Re: North East Albion Concept Plan

We are happy to give you below our feedback with regard to the Concept Plan for North East Albion, as presented at the Open House on June 24.

Bike Lanes, Multi-Use Paths and Trails

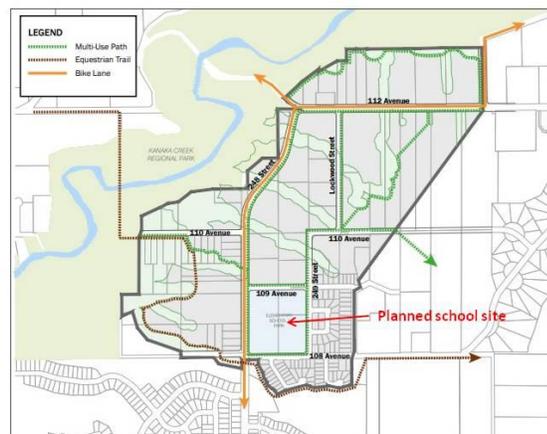
We support east-west bike lanes along 112 Ave. As indicated on display board #13, bike lanes are also planned along 248 Street (new arterial) :

112 Ave.

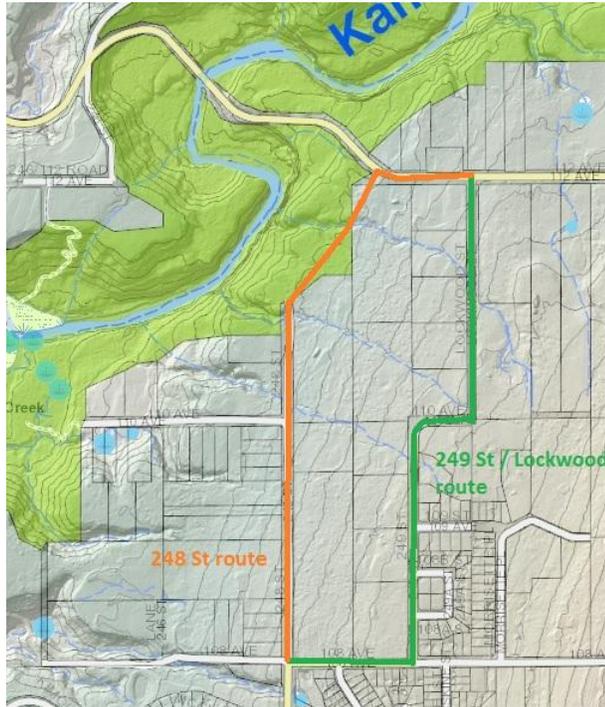
According to the street cross sections on the same display board, 112 Ave. will be constructed with bike lanes of 1.5 m, on both sides, and a buffer of 0.5 m.

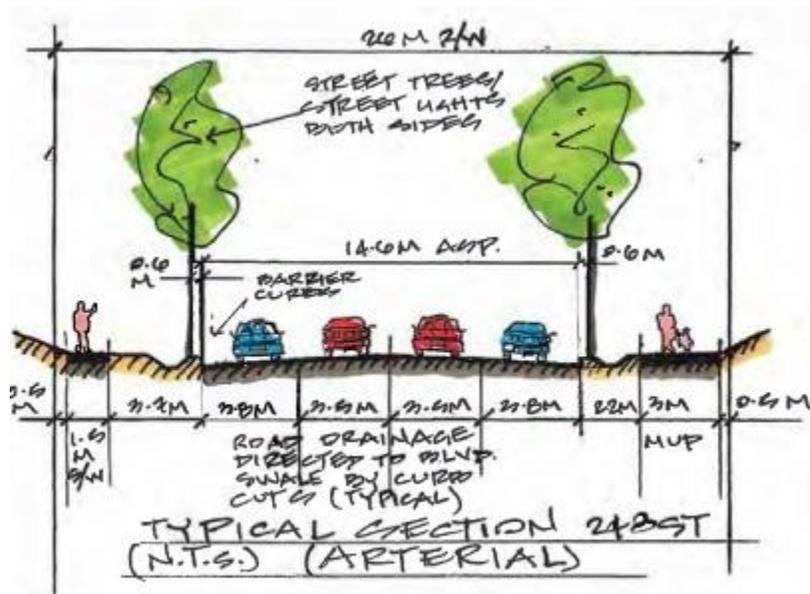
According to the 2014 Transportation Plan, the north-south designated bike route (planned shoulders) follows 108 Ave., 249 Street, 110 Ave. and Lockwood Street. We agree that 248 Street, once put through to 112 Ave., looks like a more logical and smooth continuation of the bike route:

However, according to the contour lines on Ridgeview mapping it appears that from a grade perspective, the existing designated bike route is likely more favourable:
